Access Compliance Report

Public Rights-of-Way

Intersection ID: 23302	Main Street: COLONY_RD	Cross Street: MORROWICK_RD	Location: NW
ADA ID: 43B1C24BC6A0	Ramp Type: PerpDiag	Initial Pass/Fail: Fail	Overall Compliance: No
			Severity Score: 21.25

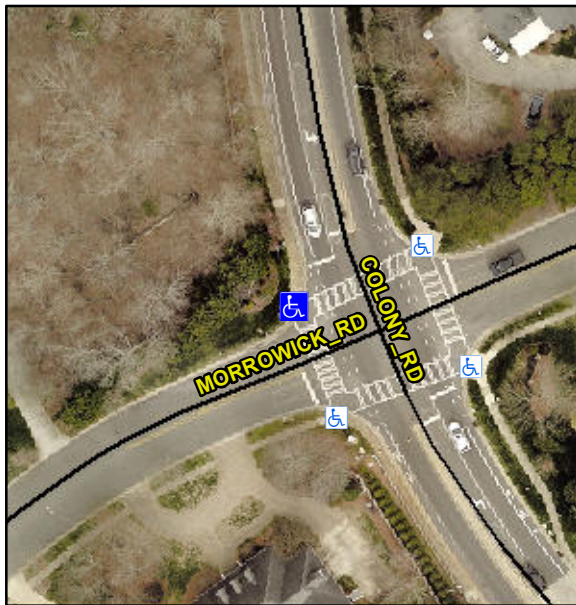
Compliance	Description	Data	Compliance	Description	Data
N/A	Ramp Length (in)	71.0	No	Ramp Slope (%)	8.5
No	Ramp Width (in)	40.0	Yes	Ramp XSlope (%)	0.9
N/A	Flare Type LT	N/A	N/A	Flare Type RT	N/A
N/A	Flare Slope LT (%)	N/A	N/A	Flare Slope RT (%)	N/A
N/A	Flare Traversable LT?	N/A	N/A	Flare Traversable RT?	N/A
N/A	Landing Length (in)	N/A	N/A	DWS Provided?	N/A
N/A	Landing Width (in)	N/A	N/A	DWS Contrast?	N/A
N/A	Landing Slope (%)	N/A	N/A	DWS Length (in)	N/A
N/A	Landing X Slope (%)	N/A	N/A	DWS Full Width?	N/A
N/A	Landing Curb? (Y/N)	N/A	N/A	DWS Offset (in)	N/A
N/A	Shared Landing?	N/A			
N/A	Gutter Ponding?	N/A	N/A	Gutter Slope (%)	N/A
N/A	Gutter Lip Ht (in)	N/A	N/A	Gutter X Slope (%)	N/A
N/A	Painted X Walk1?	Yes	N/A	Painted X Walk2?	Yes
	X Walk 1 Direction	To S		X Walk 2 Direction	To NE
N/A	X Walk 1 Width (in)	107.0	N/A	X Walk 2 Width (in)	109.0
	X Walk 1 Slope (%)	3.9		X Walk 2 Slope (%)	2.1
	X Walk 1 X Slope (%)	2.2		X Walk 2 X Slope (%)	4.5

Remove & Replace Curb Ramp With Two New Directional Ramps or Equivalent.

R304.5.1, R304.2.2
